Access Compliance Report Public Rights-of-Way (Curb Ramps)

Main Street: MILFORD_RD Cross Street: SAUGUS_AVE Location: NE

ADA ID: RPAT211007140250 Ramp Type: Type 6 - Directional 1 Initial Pass/Fail: Fail Overall Compliance: No Severity Score: 2

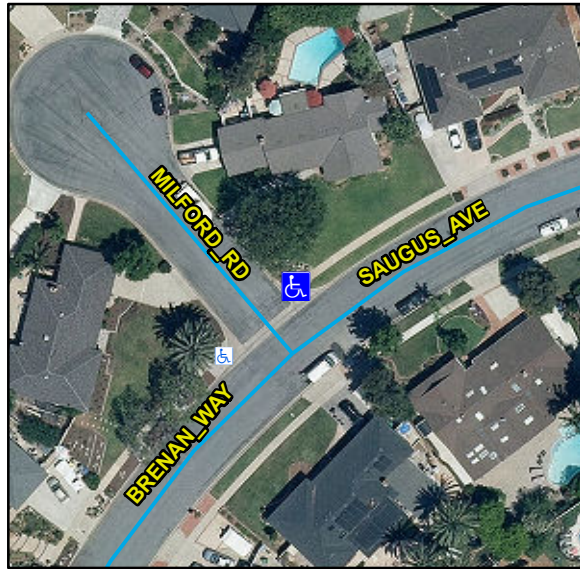
Compliance	Description	Data	Compliance	Description	Data
N/A	Ramp Length (in)	122	N/A	Flare Type LT	
Yes	Ramp Width (in)	51			N/A
Yes	Ramp Run Slope (%)	6.8	N/A	Flare Slope LT (%)	N/A
No	Ramp Cross Slope (%)	4.8	N/A	Flare Traversable LT	N/A
N/A	Grade Break	N/A	N/A	Flare Type RT	
N/A	Grade Break Slope (%)	N/A			N/A
N/A	Grade Break Cross Slope (%)	N/A	N/A	Flare Slope RT (%)	N/A
	Addl Para Ramp Left?	No	N/A	Flare Traversable RT	N/A
	Addl Para Ramp Right?	No	N/A	DWS Provided	N/A
N/A	Landing Present	N/A	N/A	DWS Contrast	N/A
N/A	Landing Length (in)	N/A	N/A	DWS Length (in)	N/A
N/A	Landing Width (in)	N/A	N/A	DWS Full Width	N/A
N/A	Landing Run Slope (%)	N/A		DWS Offset Type	N/A
N/A	Landing Cross Slope (%)	N/A	N/A	DWS Left Offset (in)	N/A
N/A	Landing Movement Obstructed?	N/A	N/A	DWS Right Offset (in)	N/A
	Landing Movement Type	N/A			
N/A	Landing Shared	N/A			
N/A	Marked Crosswalk 1	No	N/A	Clear Space	Yes
	Crossing 1 Direction	E	N/A	Clear Space To Crosswalk (in)	N/A

Remove & Replace Curb Ramp With Two New Directional Ramps or Equivalent.
